United Walnut Taxpayers (UWT)  
P.O. Box 1665  
Walnut, CA. 91788  
Contact Person, Layla Abou-Taleb, President

**UWT Response to the July 2017 NOC of Tiered Draft EIR for the Mt. SAC West Parcel Solar Project**

United Walnut Taxpayers is providing comments on the West Parcel Solar Project Tiered Project Draft EIR to 2012 Facilities Master Plan Program EIR. Comments are divided into aesthetic effects, alternatives evaluation, costs evaluation, and review of 2014 and 2017 Converse study reports and 2017 DEIR Geology and Soils section. A Table of Contents is provided below.

## Hillside Losses from Solar Project Traveling form Snow Creek Drive to Amar Road

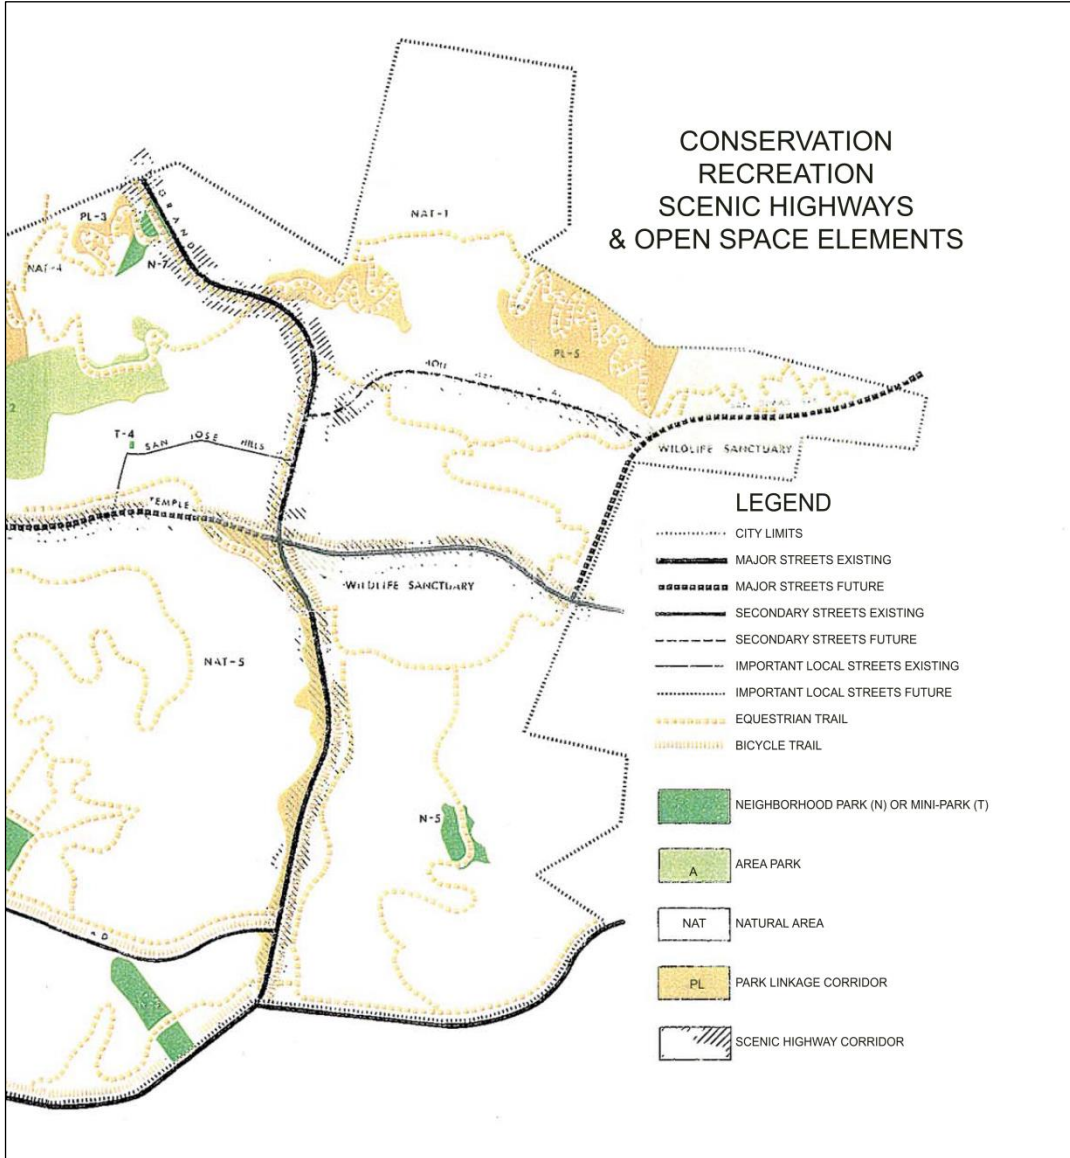
5. Motorists traveling Grand Avenue would observe loss of hillsides, which is inconsistent with the General Plan Scenic Corridor designation of the roadway. The following views of Grand Avenue (photos 1 through 3, below) traveling from south to north from Snow Creek Drive to Amar Road displays the scenic values of Grand Avenue at street level and the significant destruction of native hillsides and vegetation caused by the west parcel project.

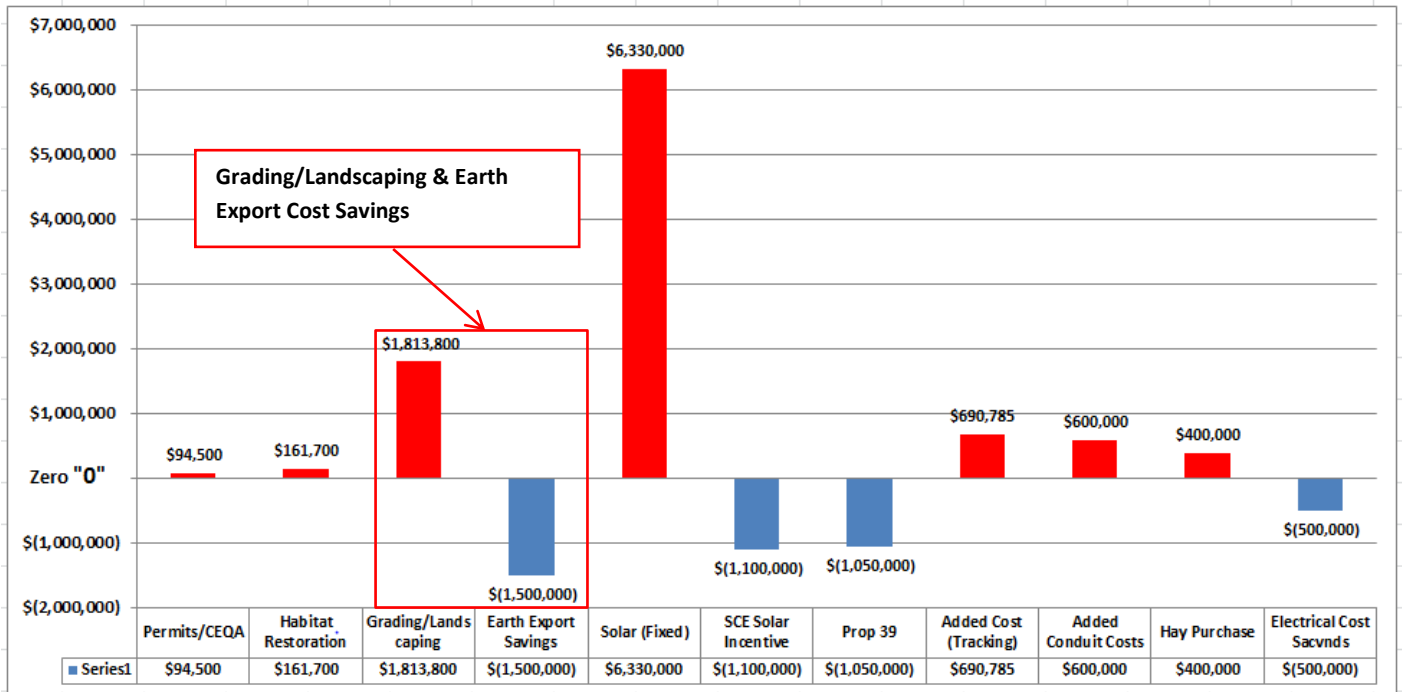
30. Given realistic unit prices in the range of \$14 per cubic yard, and earthwork quantities described above, the total grading cost was determined to be \$6,685,000 (see below), making the west parcel significantly more costly than solar panels mounted atop parking canopies or parking structures.

**Total Project Cost – West Parcel (DEIR)  
Grading/Landscaping & Earth Export Savings**

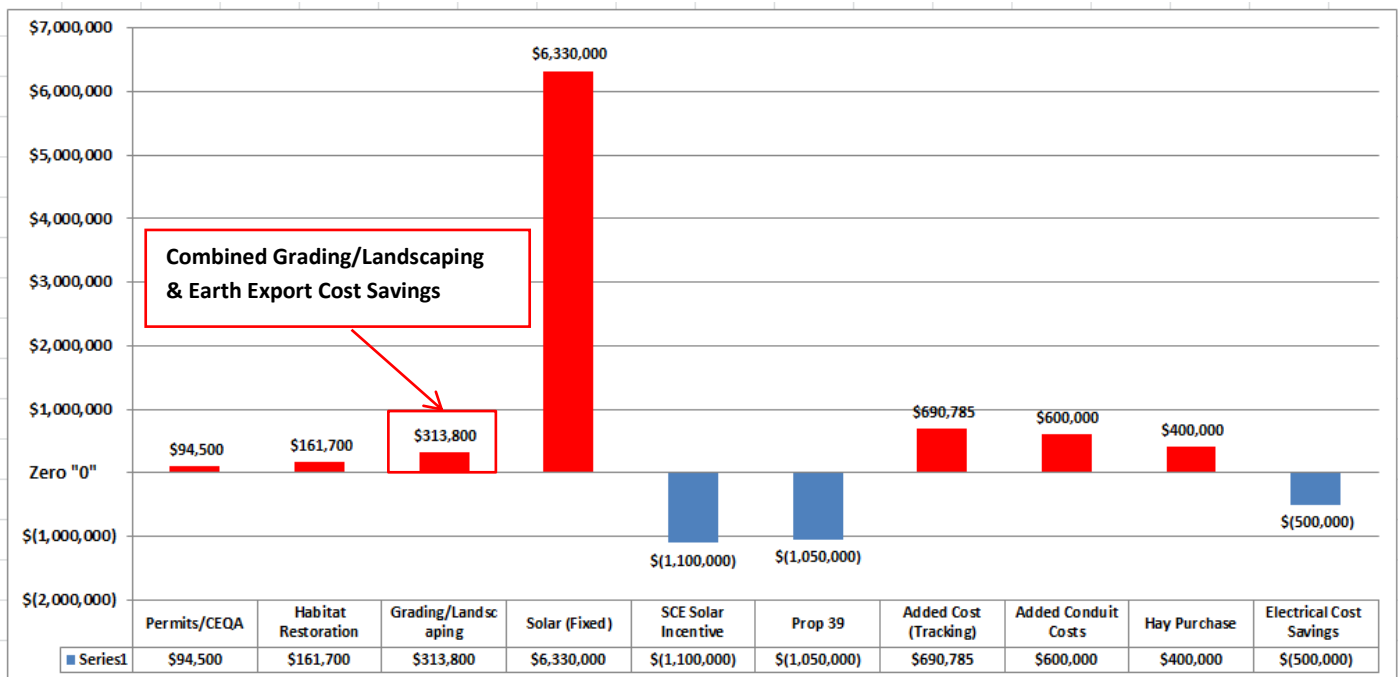
31. The first chart shows the raw WPSP costs in the DEIR. It includes the various costs adjustments and credits applied by Mt. SAC after the construction costs are developed. The third vertical bar is the grading cost. The fourth bar is grading savings (a negative cost) if the stadium hill dirt is exported to the west parcel and not off-site.

33. These costs also do not account for possible additional remediation of landslides associated with High Landslide Potential lands identified on the LA County Engineer mapping for the City of Walnut General Plan and on the California Geological Survey CGS 88-21 Map No. 12 for this region, designating most lands at the west parcel at “close to their stability limits”.

### Table 6.6.1 Alternatives Cost Comparison (Sensitivity of Cost to Mt. SAC Assumptions)

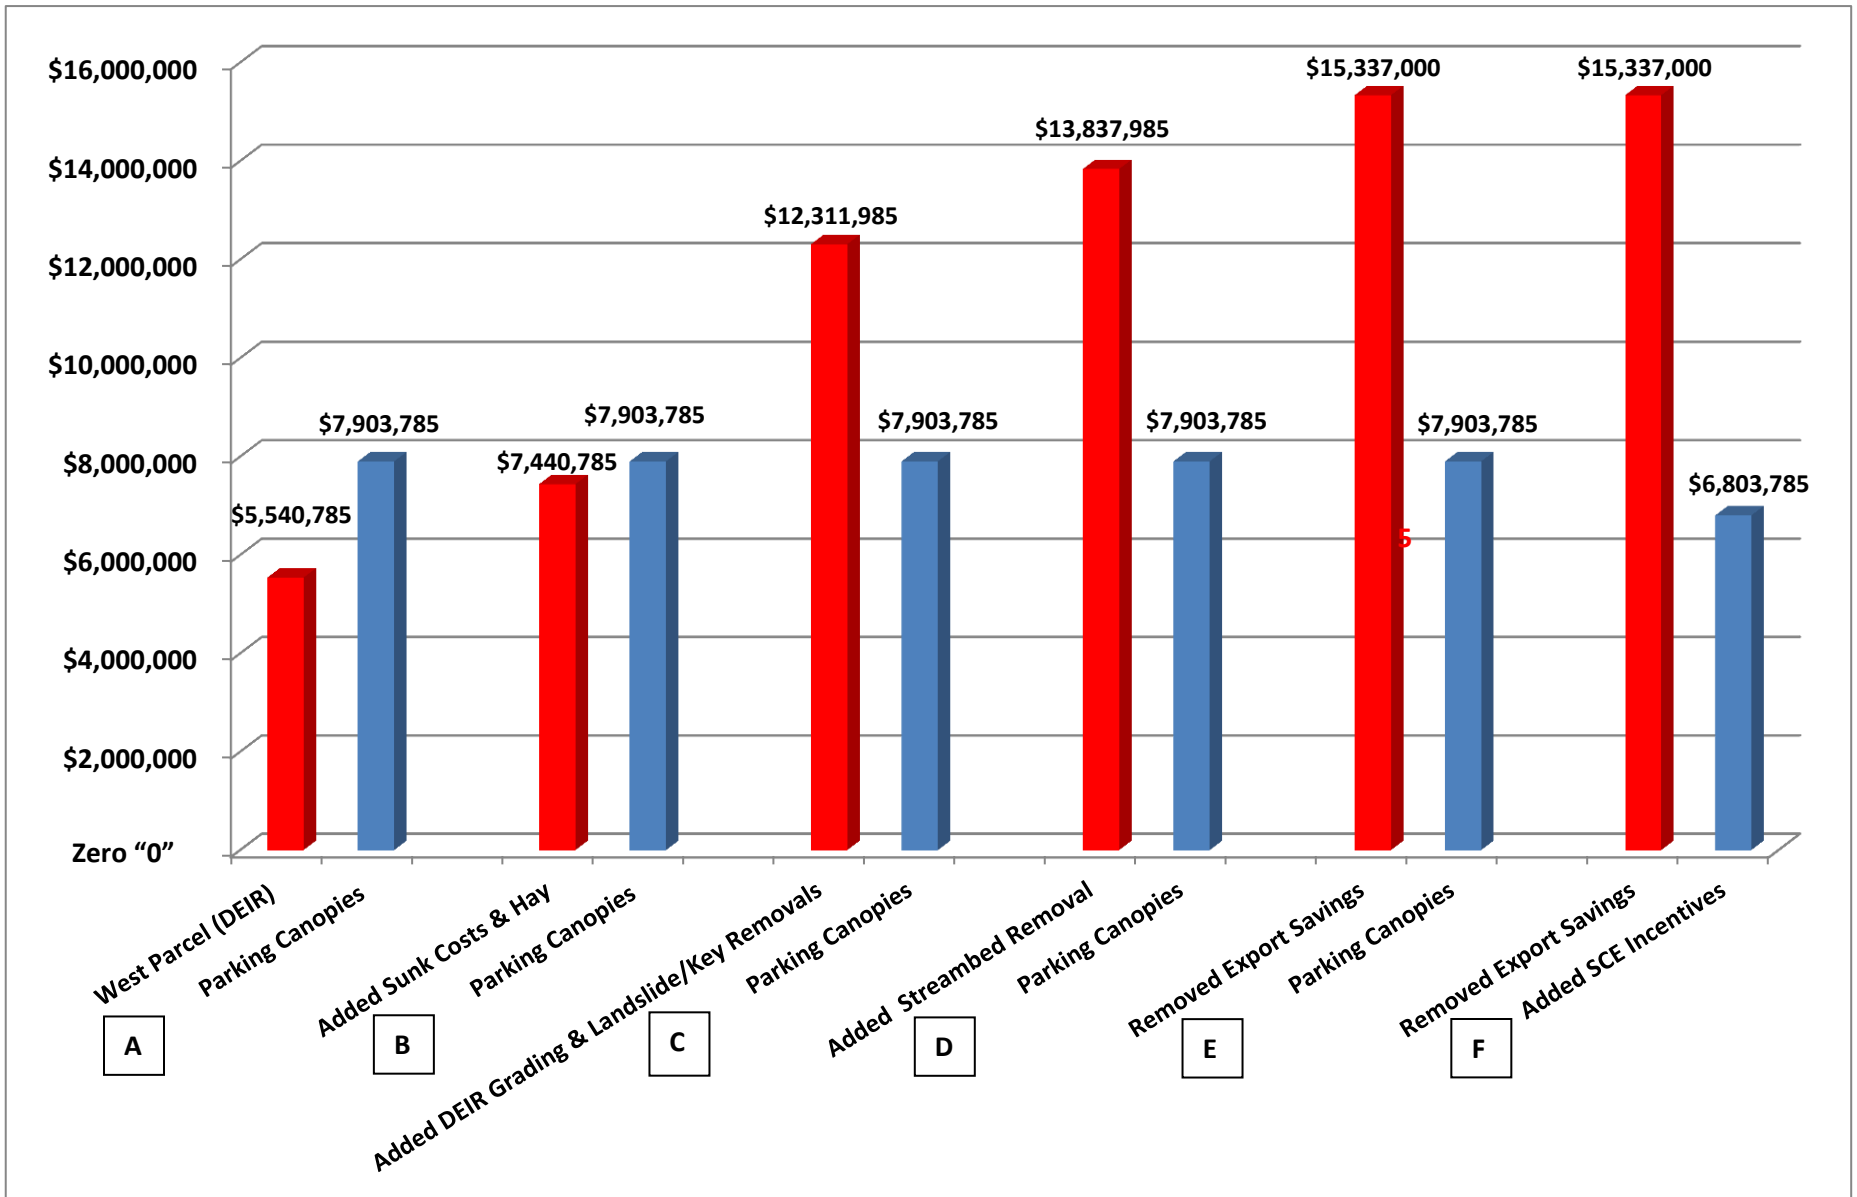
39. The total project costs depicted on Table 6.6.1 of the DEIR provides inadequate back-up information to evaluate the project costs. As such and as shown above, the development of costs for grading and for canopy-mounted solar arrays have been developed by UWT for comparison purposes.

- b. Vertical Bars B. Sunk cost and hay cattle feed replacement for loss of hillside grass are added to the red bar, which were left off the west parcel in Table 6.6.1.

- c. Vertical Bars C. West parcel earthwork, landslide removal and dirt import from the stadium, identified in or characterized in the DEIR, are added to the red bar costs. The third set of bars

- d. Vertical Bars D. Additional earthwork consisting of streambed materials removal and replacement, recommended by Terrestrial Solutions, Inc. (TSI) are added to the red bar.

- f. Vertical Bars F. A credit is added to the blue bar for a SCE incentive program (a reduction in cost) since a new SCE Net Energy Metering (NEM 2.0) program was initiated on July 1, 2017.

**Figure 3a**

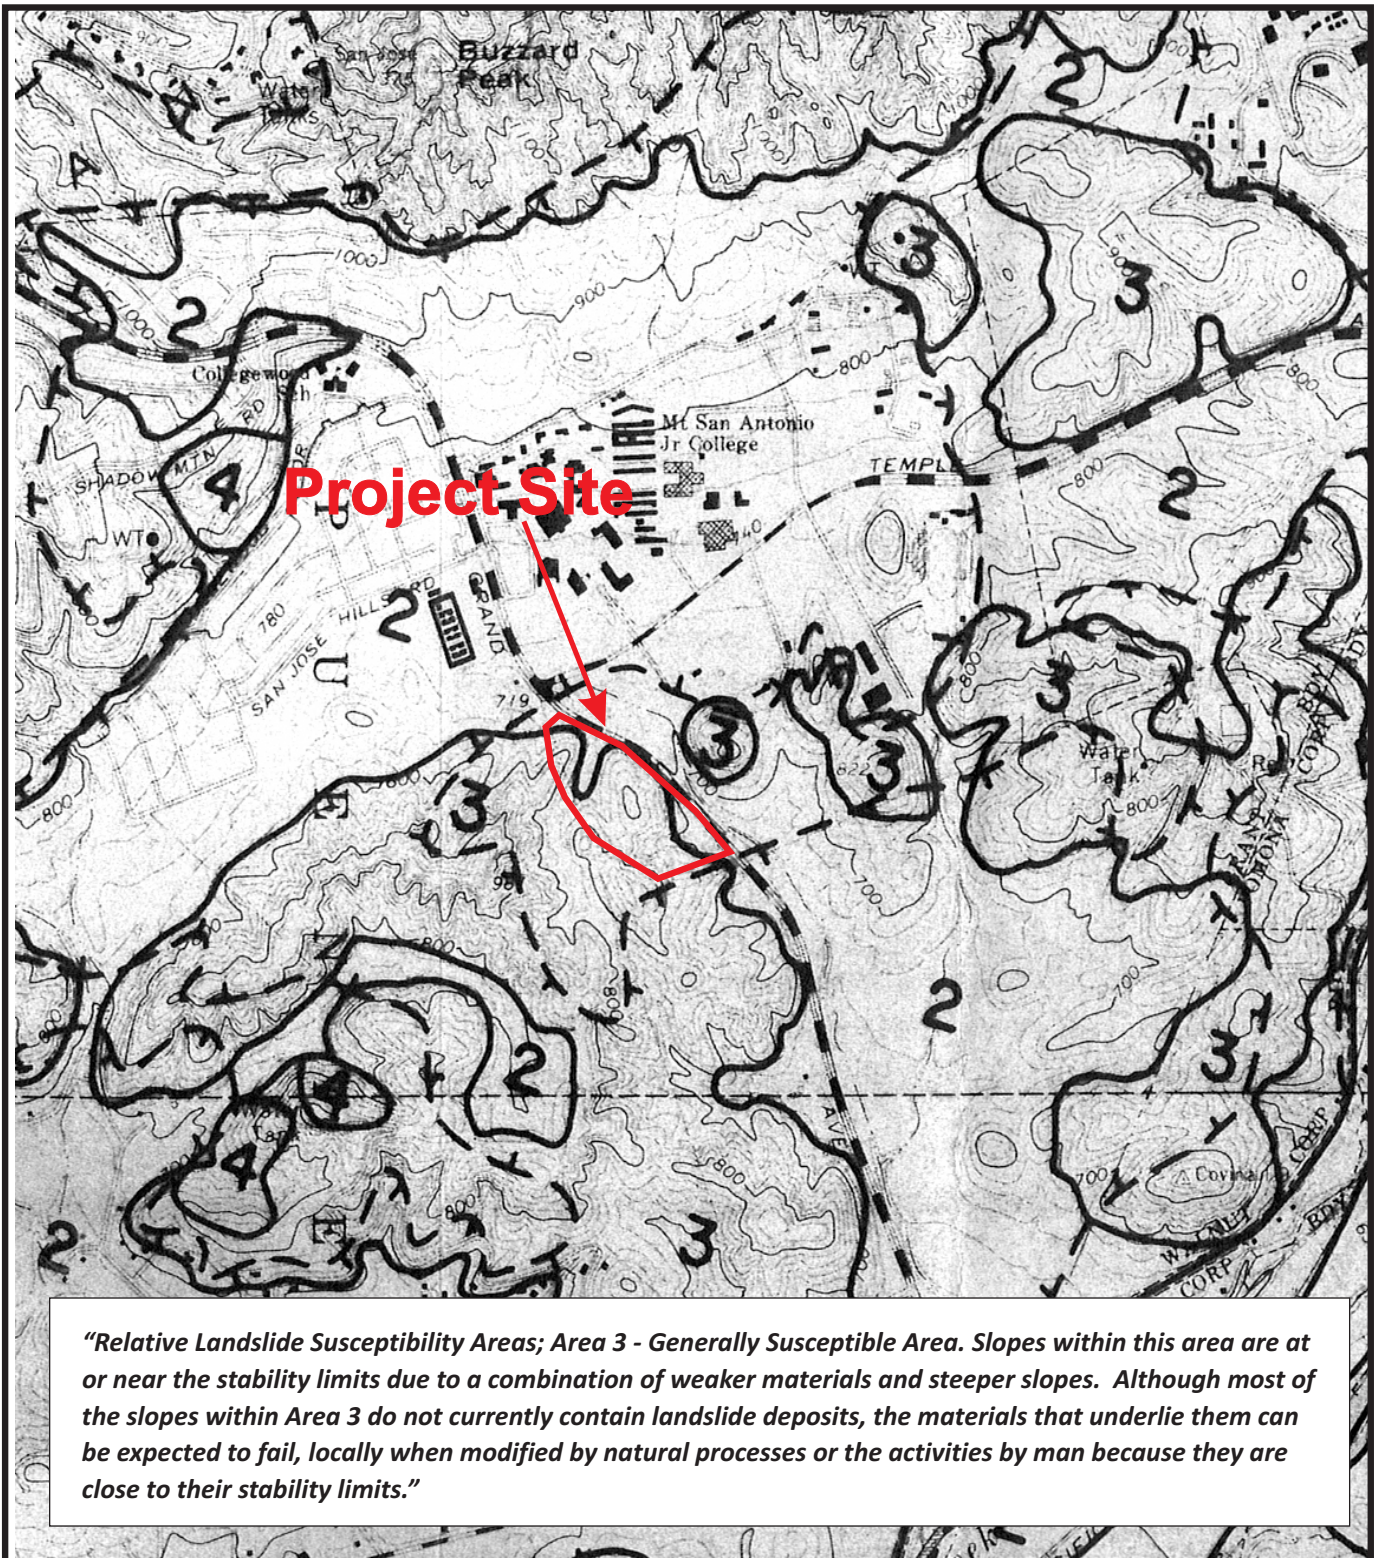
Converse correctly indicates that, according to official maps published by the State, the site is not located in an area that must be investigated for seismically induced landsliding. However, the Converse report does not reference the LA County Engineer Landslide Potential Map (Plate II, 1974) that indicates portions of the site have a high potential for landsliding (Figures 2a and 2b). In addition, Converse did not reference CGS Open File Report 88-21 that indicates the site is within Area 3 (Figures 3a and b). Area 3 is defined as;

*"Relative Landslide Susceptibility Areas; Area 3 - Generally Susceptible Area. Slopes within this area are at or near the stability limits due to a combination of weaker materials and steeper slopes. Although most of the slopes within Area 3 do not currently contain landslide deposits, the materials*

*that underlie them can be expected to fail, locally when modified by natural processes or the activities by man because they are close to their stability limits.”*

These figures clearly indicate that the proposed project is within areas that were previously determined by governing agencies to have a significant potential for slope instability and landsliding.

**Figure 5**

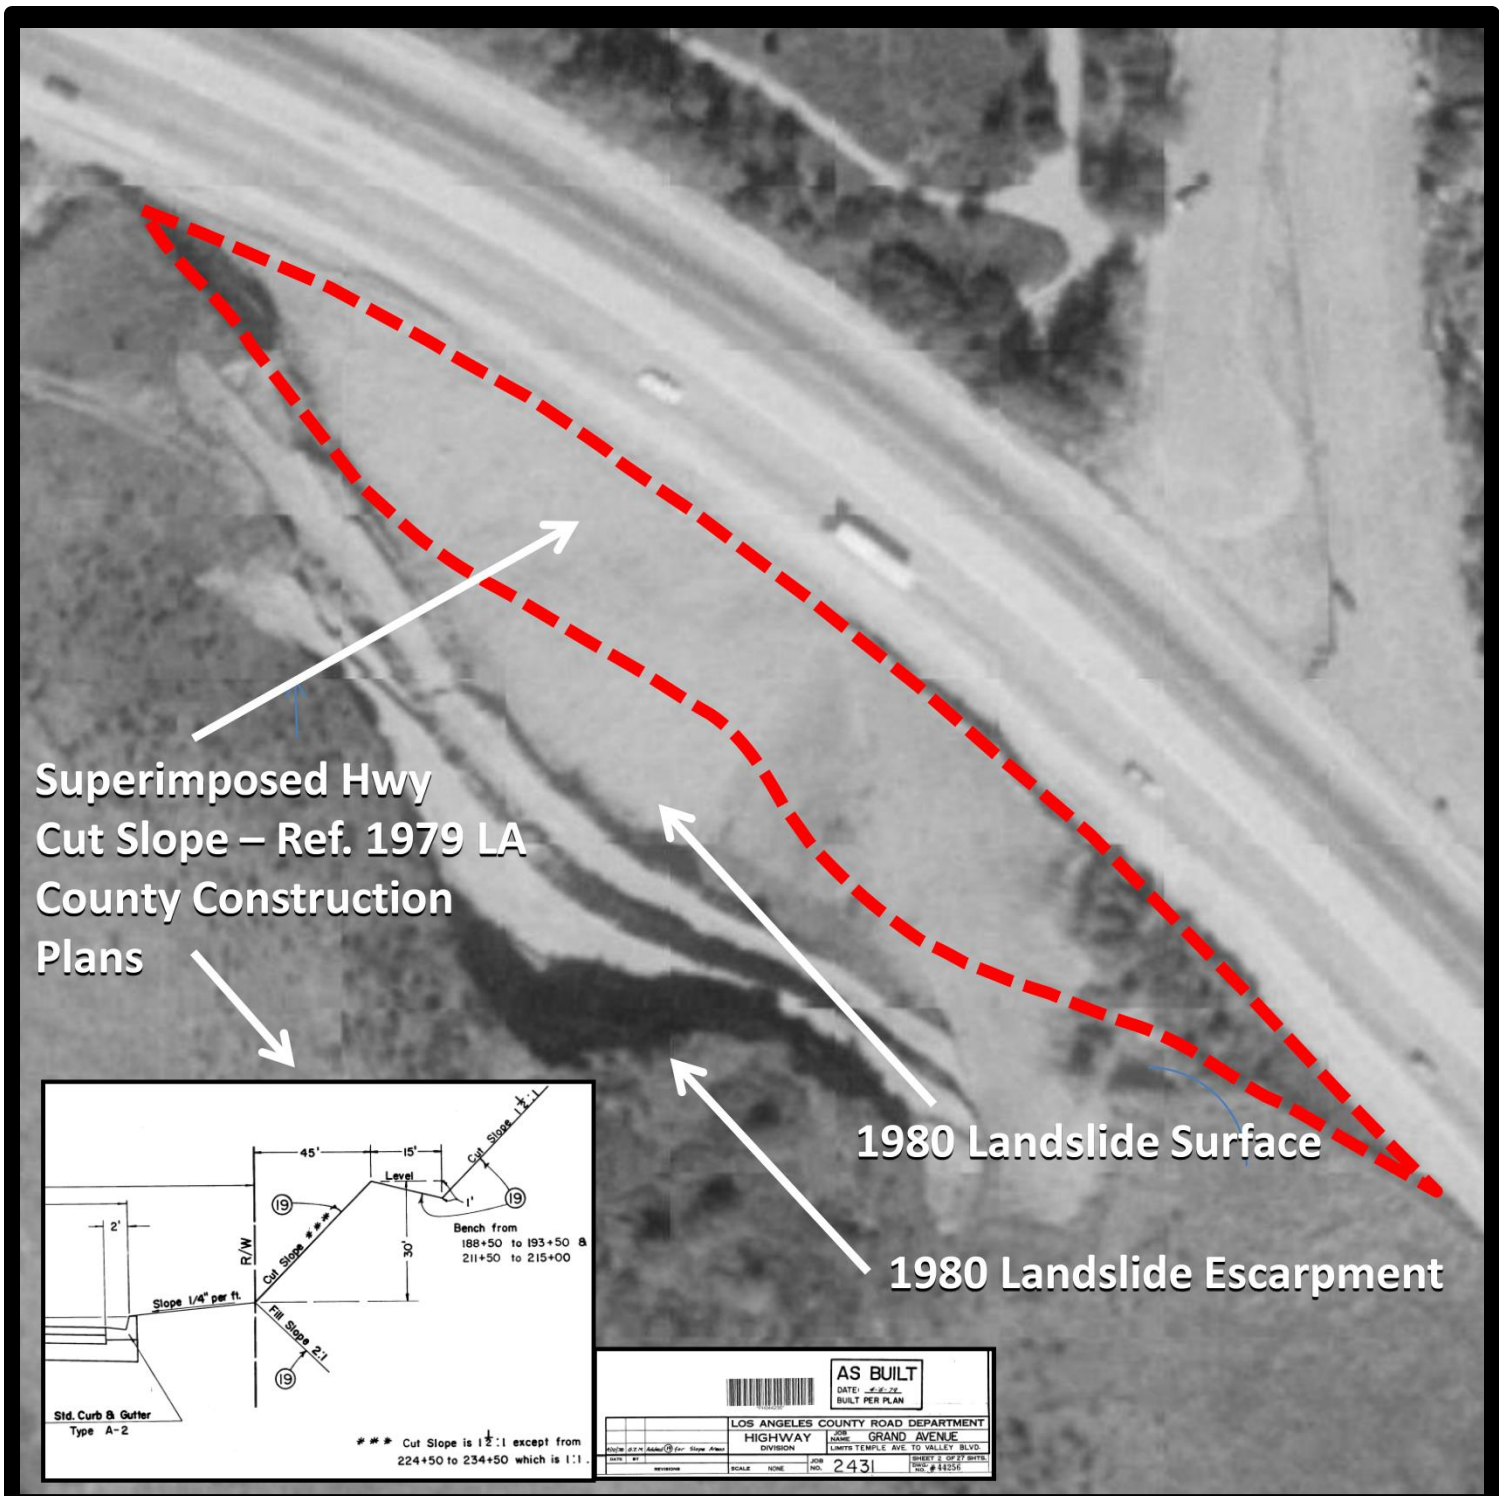
The slope along Grand Avenue consists of variable cut, fill, and in some locations, fill over the existing slope. As discussed earlier, the central hill portion of the site along Grand Avenue is underlain by a landslide. The proposed cut slope in this area will most likely not remove all the landslide debris, and the underlying cause(s) of the landslide. The geologic conditions (including the presence of the landslide) have not been modeled by Converse for the differing conditions along the length of this proposed slope. No specific stability analysis was provided for any of this variable slope which is nearly 2000 feet in length and up to 80 feet in height. Grand Avenue is a major roadway within the City of Walnut and is located at the toe of this proposed slope. Therefore, understanding the stability of this slope is a critical aspect of this project.
